Re: Four-Unit combustion Turbine Facility at Indian River Plant
AC 05-193720 & PSD-FL-173

Re: Combustion Turbine Facility
Indian River Plant
AC 05-193720 - PSD-FL-173

**OUC - INDIAN RIVER
PREVENTION OF SIGNIFICANT DETERIORATION (PSD)
PERMIT APPLICATION**

ATTACHMENT - RESPONSES TO FDER COMMENTS

FIGURE 1

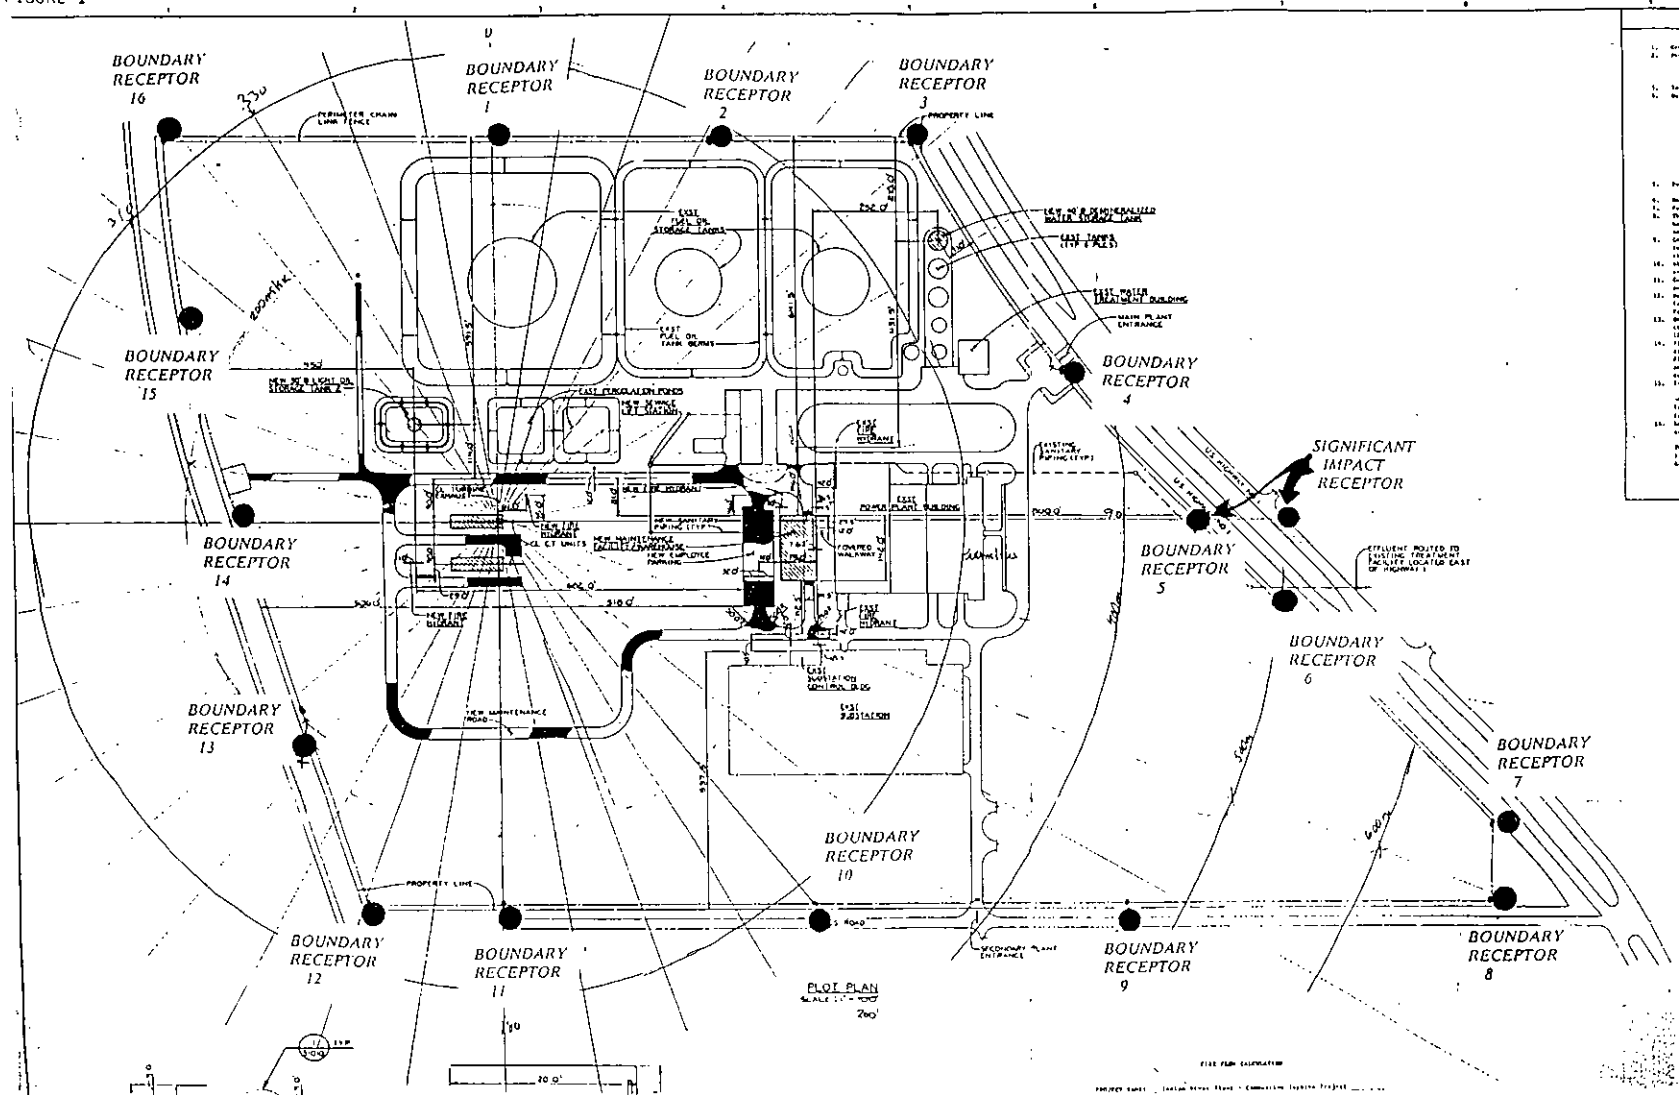
Please provide a figure detailing the plant's boundary and the location of boundary receptors used in the modeling analysis. Also, provide a discussion detailing what measures are in place to prohibit public access to the plant's property.

2. Please provide a figure detailing the plant's boundary and the location of boundary receptors used in the modeling analysis. Also, provide a discussion detailing what measures are in place to prohibit public access to the plant's property.

The plant boundary and the modeled boundary receptors are shown in attached Figure 1. As shown, receptors are located at approximately 200-meter intervals

along the property boundary. The coordinates of these receptors relative to the Unit A combustion turbine stack were listed in the modeling output provided as part of the PSD permit application.

A chain link fence is located around the perimeter of the property boundary. This fence prohibits public access onto the plant property.
